SYSTEM ENGINEERING ACTION PLAN

RANCHO SECO NUCLEAR GENERATING STATION

REPORT No. SYSTEM-009

SUBJECT: LETDOWN COOLER THERMAL AND HYDRAULIC SHOCK PREVENTION

ORIGINATOR	DWN COOLER SCHEMATIC FIGURE 1	CALC. NO	OF
8	SFV- 22005	E-ZZOA N	HV- 22007
,	ev- 025 9	PLS-131	SFV- SFV- 22023 22009
P.2(58** T. 530F	SFV- 22006	E-2208	X 9
31		P5V-22024 E-220C	PLS-132
33 34 35 36 36 36 36 36	The second secon	ccw

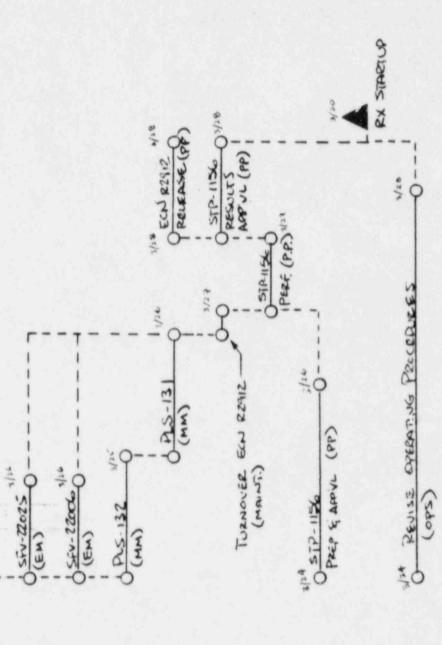
NRC Observation: Letdown Cooler Modifications: Operations commitment to issue appropriate instructions to plant operators regarding lineup of letdown coolers in a timely manner was not implemented.

Rancho Seco Response: The Director, Nuclear Operations & Maintenance was tasked by the AGM-Nuclear Power Production to investigate why Operations personnel were not made aware of the new letdown cooler philosophy. Specifically, he is to determine the cause of the breakdown is communication which resulted in the failure to seem a shift order indicating that only one cooler should be in service and installing labels indicating the same.

This investigation revealed that the failure to meet the commitment was caused by a momentary breakdown in routine management short term job assignment and followup. Contributing factors were the high level of activities associated with reactor startup, the change in shift schedule to the night shift for the assigned individual, and the lack of a specific due date. This breakdown is not indicative of a programmatic failure within the department as indicated by the timely completion of all other letdown cooler modification tasks, including six procedure changes.

Corrective actions included a review of the incident with Operations management staff stressing the need to establish firm due dates for all activities.

The Director, Nuclear Operations and Maintenance discussed this issue in detail with J. Crews, NRC Team Leader, and resolve all concerns. This issue is considered closed.
